From: Ryan Faust <faustr@bufstudio.co>
Sent: Tuesday, June 6, 2023 8:07 AM
To: Wood Hicken, Amber; Macy Nance
Subject: RE: Horizontal Massing Breaks - Andy's Custard

From: Wood Hicken, Amber <ahicken@parkeronline.org>
Sent: Tuesday, May 23, 2023 2:58 PM
To: Ryan Faust <faustr@bufstudio.co>
Subject: Horizontal Massing Breaks - Andy's Custard

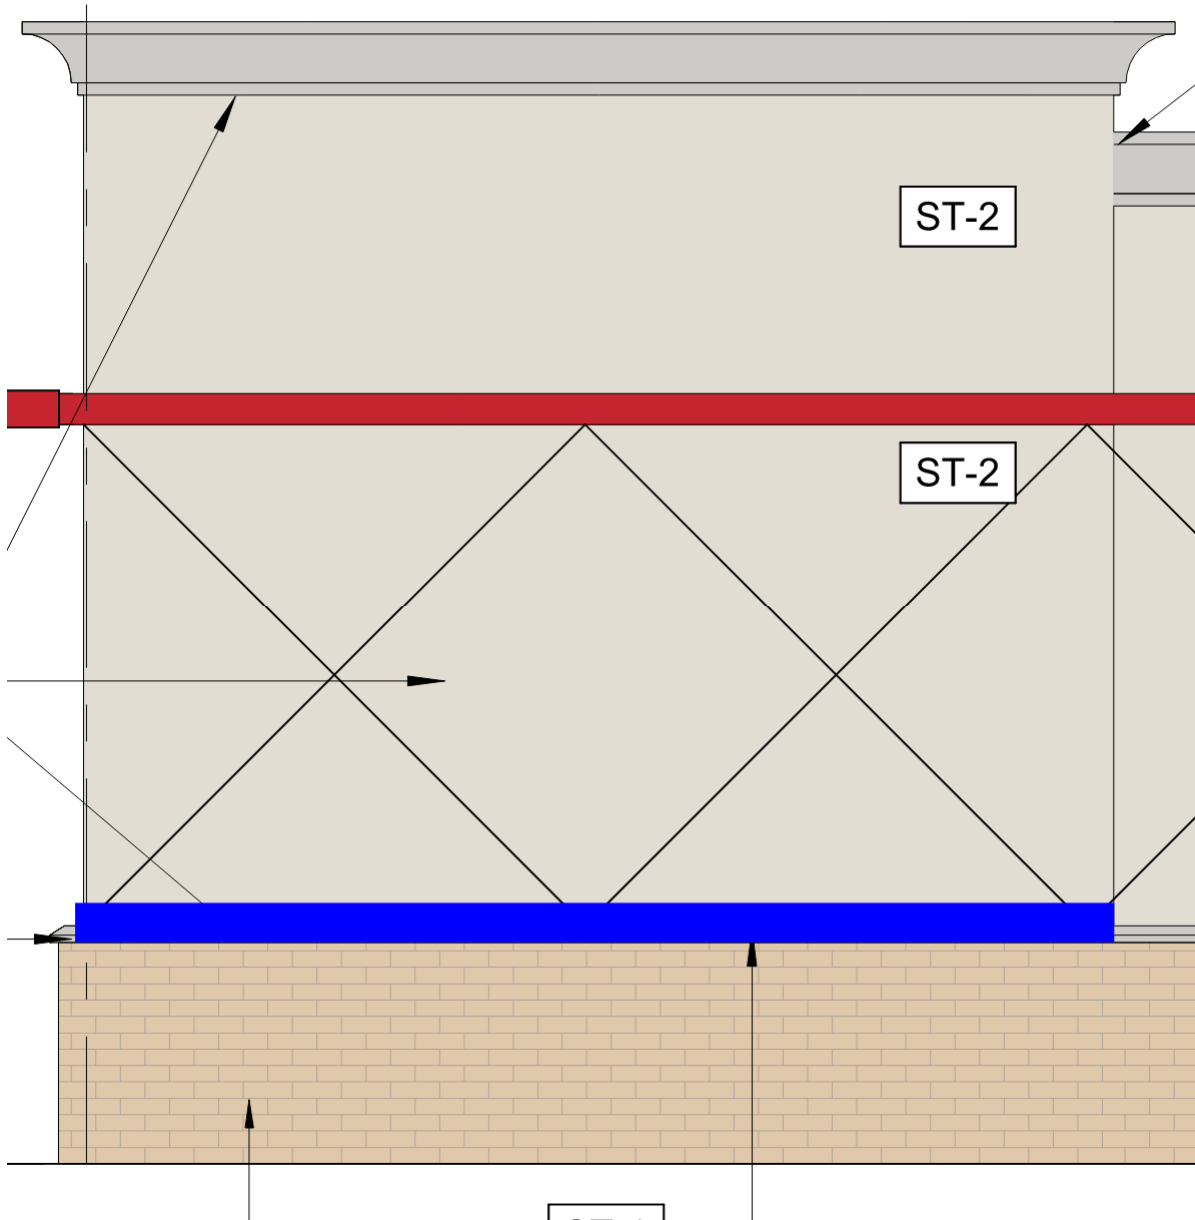
Following up on this one for you; we changed the watertable to be taller or what I had mentioned before of a more vertical plane rather than a small angled watertable. I also had the team adjust the rear elevation with the glazing to have brick all the way up. I do think this helps the rear elevation to match to the other elevations with material selection and articulation, so hopefully that provides some more contrast and a higher level of articulation across the façade to support your comments.
